# PLANNING DESIGN STUDIO

Location: 8419 Manchester Road, Brentwood, MO

Referenced Subject: Landscape Plan Review Initial Comments on:  
Site and Landscape Plans dated December 30, 2020.

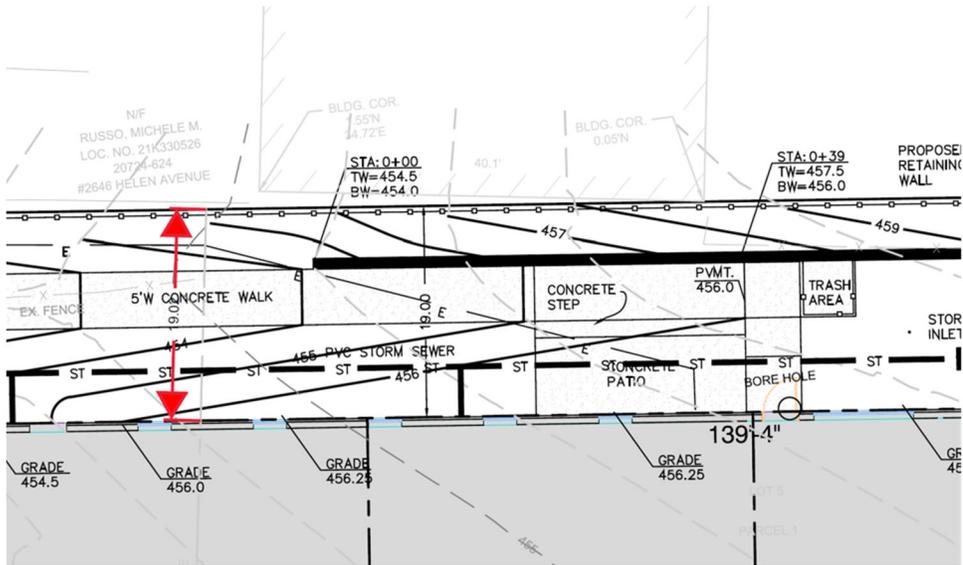
- c. The site plan should provide more detail about how the concrete vertical curb should be designed to become flush with the parking lot and the concrete walk at the ADA

parking spaces near the building entrance. If a ramp is needed it should be shown in the site plan.
